Access Compliance Report

Public Rights-of-Way

(Curb Ramps)

Intersection ID: 11707	Main Street: N_GRAHAM_ST	Cross Street: W_6TH_ST	Location: N
ADA ID: FA219C4D7BAE	Ramp Type: Directional1	Initial Pass/Fail: Fail	Overall Compliance: No
			Severity Score: 37.5

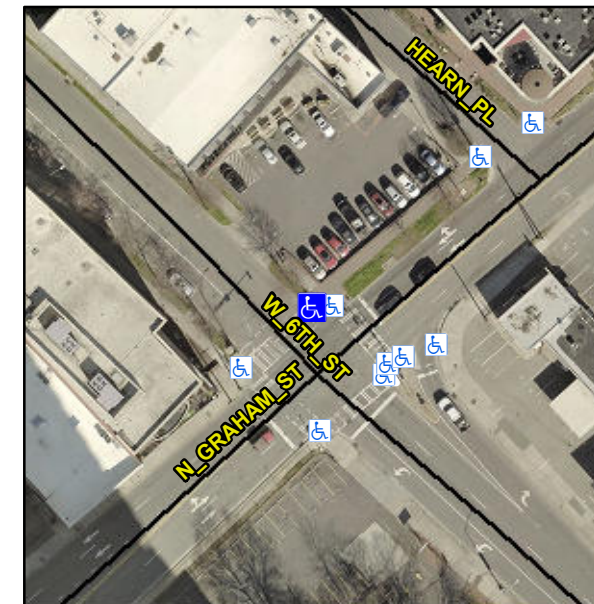
R304.2.2, R304.5.3

Compliance	Description	Data	Compliance	Description	Data
N/A	Ramp Length (in)	66.0	N/A	Grade Break?	N/A
Yes	Ramp Width (in)	48.0	N/A	Grade Break Slope (%)	0.0
No	Ramp Slope (%)	12.3	N/A	Grade Break XSlope (%)	0.0
No	Ramp XSlope (%)	5.7			
N/A	Flare Type LT	N/A	N/A	Flare Type RT	N/A
N/A	Flare Slope LT (%)	N/A	N/A	Flare Slope RT (%)	0.0
N/A	Flare Traversable LT?	N/A	N/A	Flare Traversable RT?	N/A
N/A	Landing Length (in)	0.0	N/A	DWS Provided?	N/A
N/A	Landing Width (in)	0.0	N/A	DWS Contrast?	N/A
N/A	Landing Slope (%)	0.0	N/A	DWS Length (in)	N/A
N/A	Landing X Slope (%)	0.0	N/A	DWS Full Width?	N/A
N/A	Landing Curb? (Y/N)	N/A	N/A	DWS Offset LT (in)	N/A
N/A	Shared Landing?	N/A	N/A	DWS Offset RT (in)	N/A
N/A	Gutter Ponding?	0.0	N/A	Gutter Slope (%)	N/A
N/A	Gutter Lip Ht (in)	0.0	N/A	Gutter X Slope (%)	N/A
N/A	Painted X Walk1?	Yes		Road Slope (%)	5.3
	X Walk 1 Direction	To SW		Road X Slope (%)	1.3
	X Walk 1 Width (in)	131.0		Clear Space?	N/A

Remove & Replace Entire Ramp.
